Town of Hilton Head Island Regular Design Review Board Meeting

REVISED AGENDA

DESIGN TEAM/DRB COMMENT SHEET

A2
A1.01 **SIDE ELEVATION**
SCALE: 1/4"=1'-0"

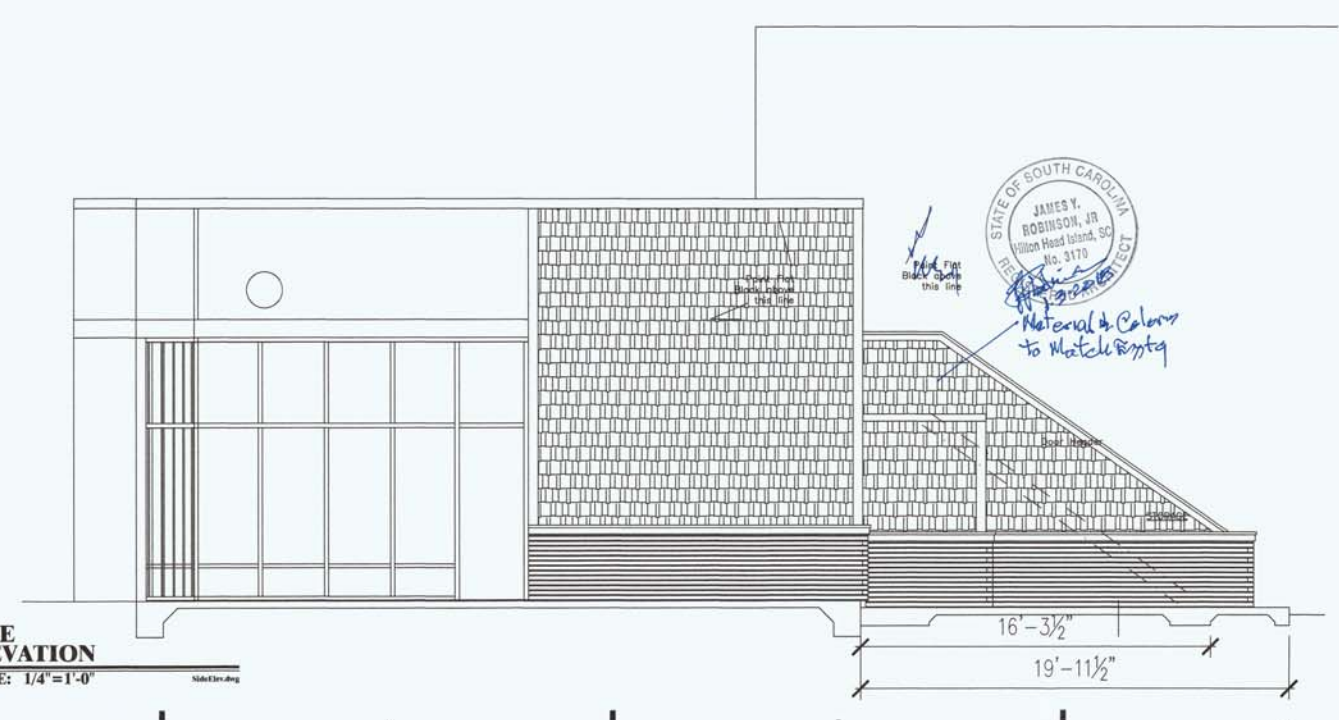
MISC COMMENTS/QUESTIONS
On page A-3.01, Elevation A2, Side Elevation, there are notations that state "Paint Flat Black above this line." Please clarify or correct, There is no flat black on the facades of the existing buildings. Applicant revised.
